Applicant's Response to Written Representations

PINS Reference Number: EN010069

Deadline 2 – 30 November 2018

- 1.1.1 The Applicant, Abergelli Power Limited, is applying to the Secretary of State (SoS) under the Planning Act 2008 (PA 2008) for development consent to construct, operate and maintain an Open Cycle Gas Turbine (OCGT) gas fired peaking power generating station, fuelled by natural gas with a rated electrical output of up to 299 Megawatts (MW) (the Abergelli Power Project).

ANCIENT WOODLAND AND ACCESS ROAD

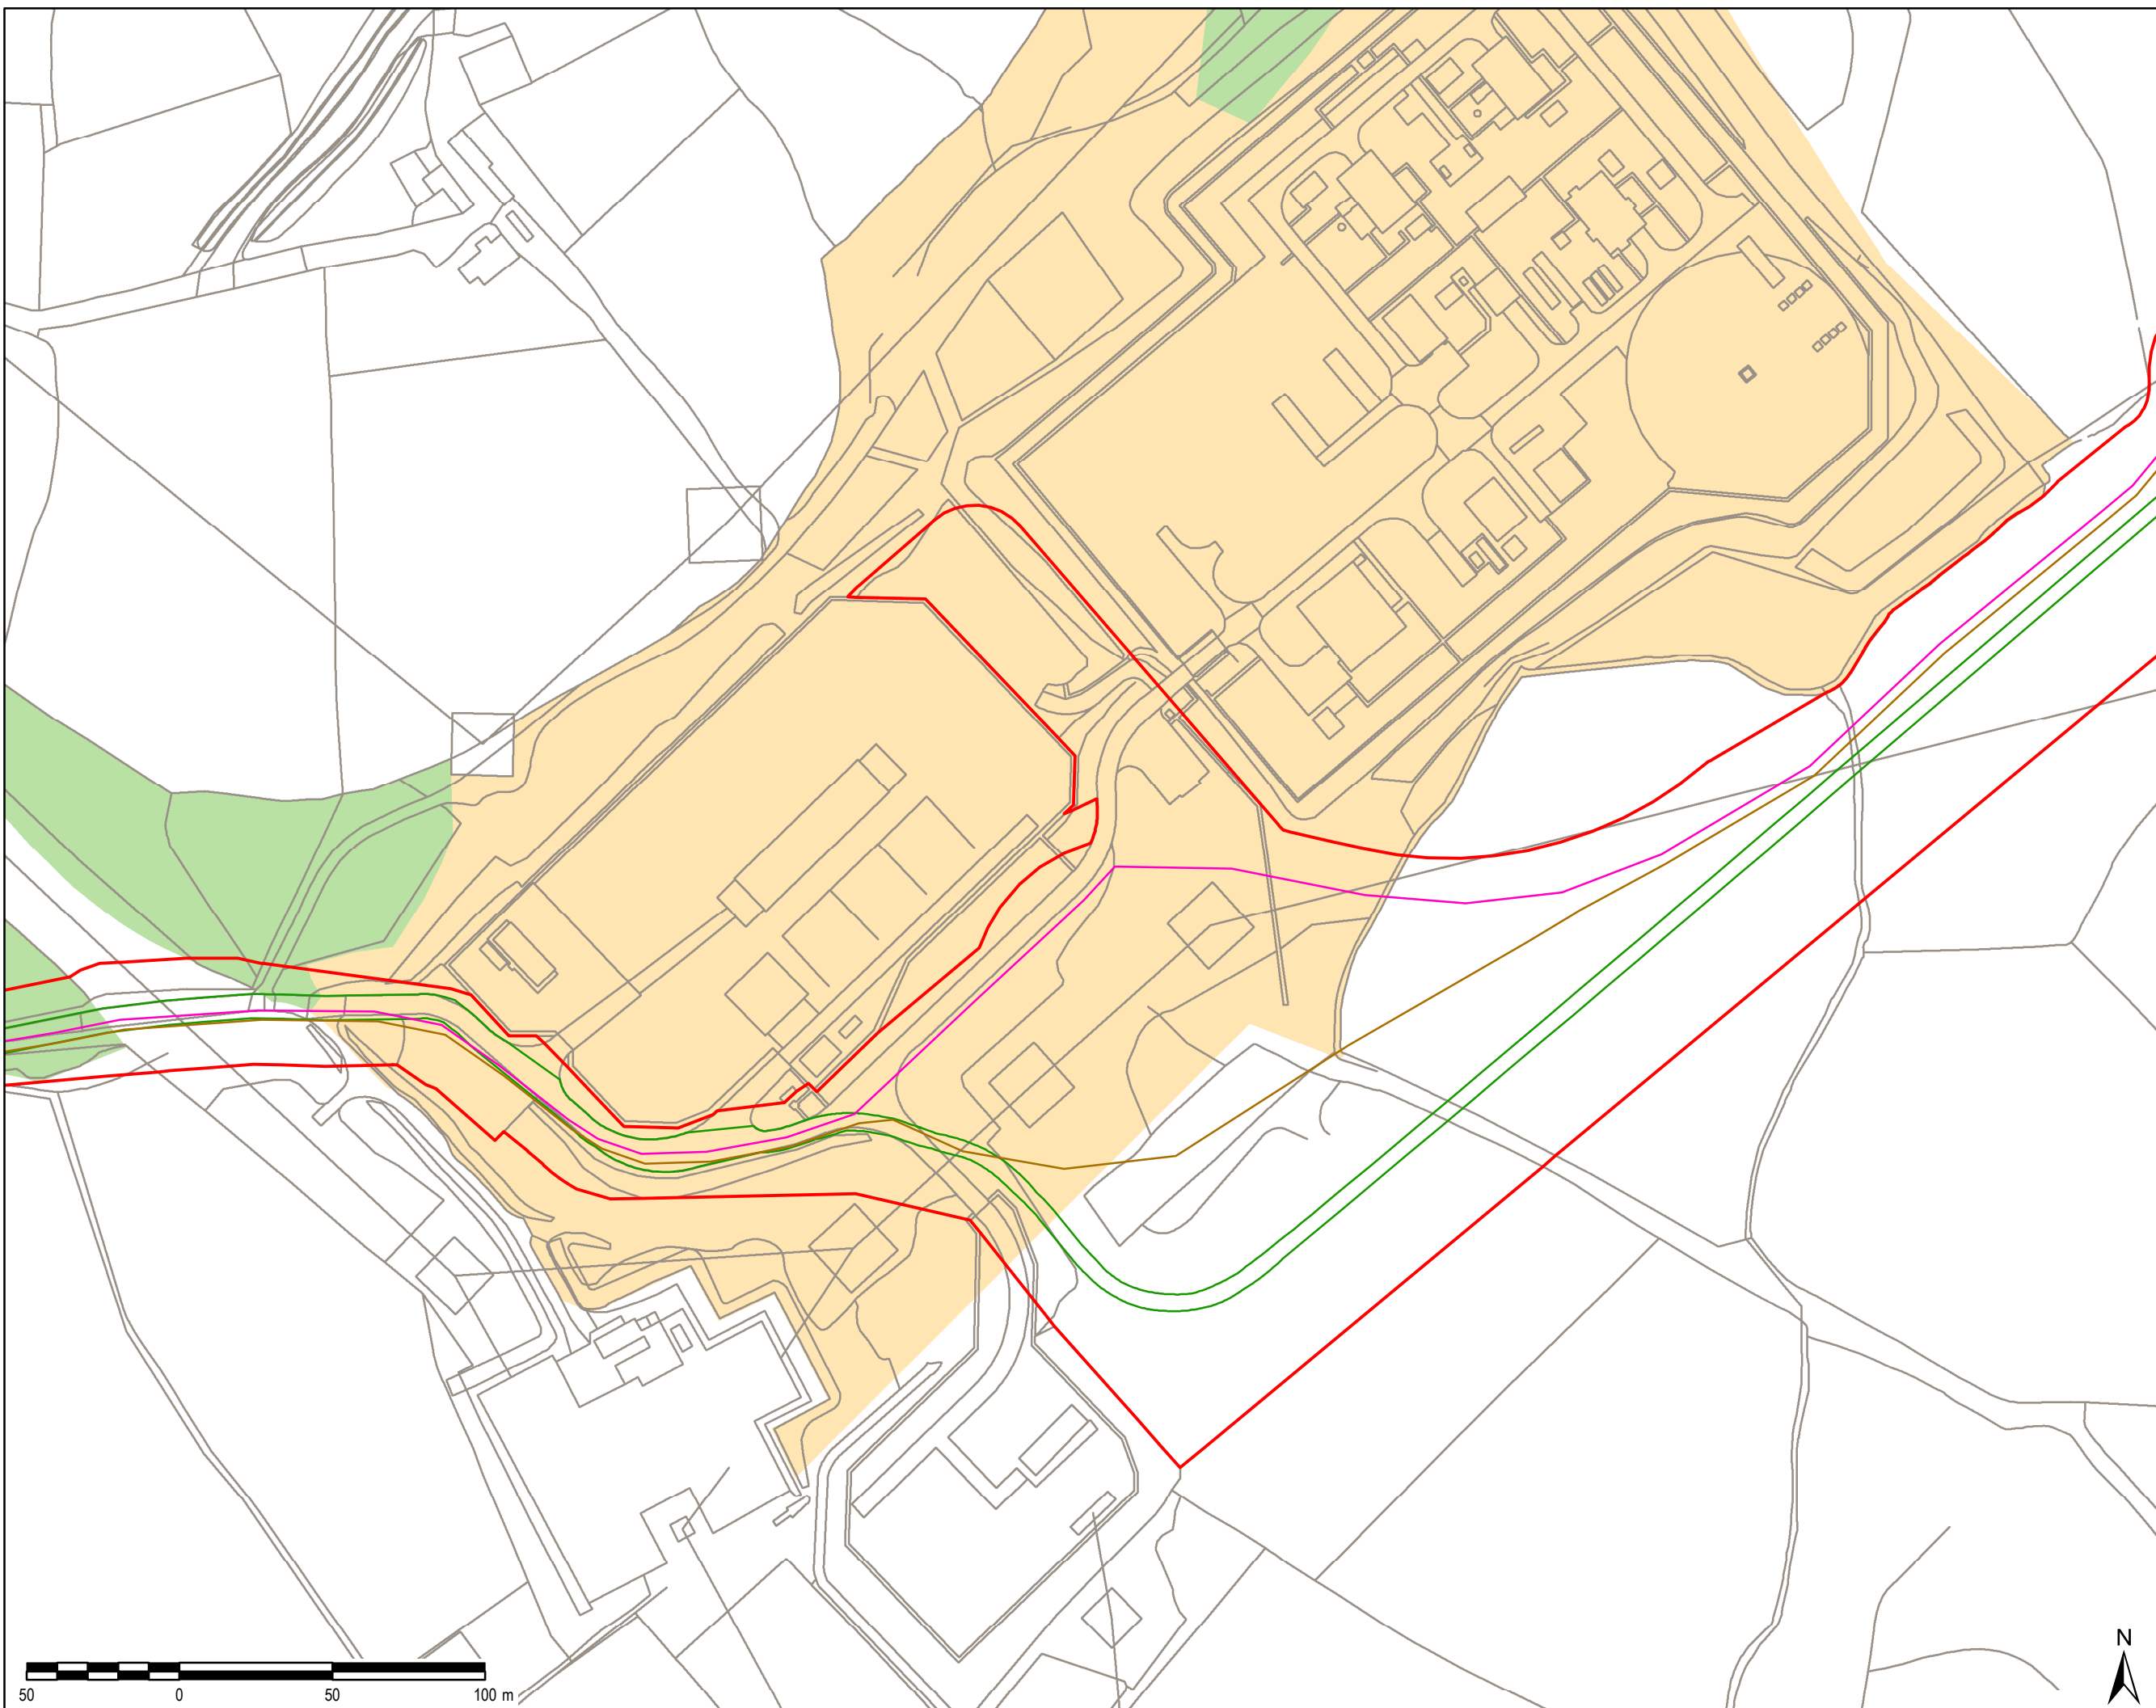
3.3.3 The Respondents assert that the Applicant has incorrectly identified woodland to be ancient woodland when it is not, and that that factual error has influenced the selection of the route.

- 5.21 The Applicant has reviewed the report by Alison Wheeler from Hugh Wheeldon & Co (Appendix D to the Respondents' written representation) with its consultants.

- 5.22 The Ancient Woodland Inventory (www.lle.gov.wales), shows that not all the woodland through which the Option B Access Track is located is recorded as Ancient Woodland. The drawing at Appendix 1 shows an overlay of ancient woodland and the access routes. The ancient woodland colourings are taken from the Ancient Woodland Inventory, and show restored ancient woodland in orange tinting, and ancient woodland of unknown category tinted in pink. The route of Option A access route is the pink line, Option B is the brown line and the route of the revised Option B (now included as the Access Road in the draft DCO) in green.

- 5.23 However, the areas of woodland (ancient and unclassified) are contiguous, and both exhibit similar characteristics. Furthermore, as stated in the Ecological Appraisal (Hugh Wheeldon & Co., May 2018)

5.28 As such it is desirable to avoid both areas of woodland.

5.29 The Standing Advice also recommends leaving an appropriate buffer zone of semi-natural habitat between the development and the ancient woodland (depending on the scale and impact of development, a minimum buffer should be at least 15 metres to avoid root damage and at least 50m for pollution or trampling); the width of the woodland not classified as ancient is approx. 15m. As such, any access route through this area would need to avoid the whole area of woodland (ancient and unclassified) to adhere to this best practice guidance.

5.31 The Applicant therefore refutes the Respondents' suggestion that the selection of the access route was flawed and based on an incorrect understanding of the status of the ancient woodland. The evidence reviewed by the Applicant supports the Applicant's conclusion that the woodland should be treated as ancient woodland, and the modifications to the access route to avoid the destruction of ancient woodland is in accordance with the NPS policy and endorsed by the statutory nature conservation body, Natural Resources Wales.
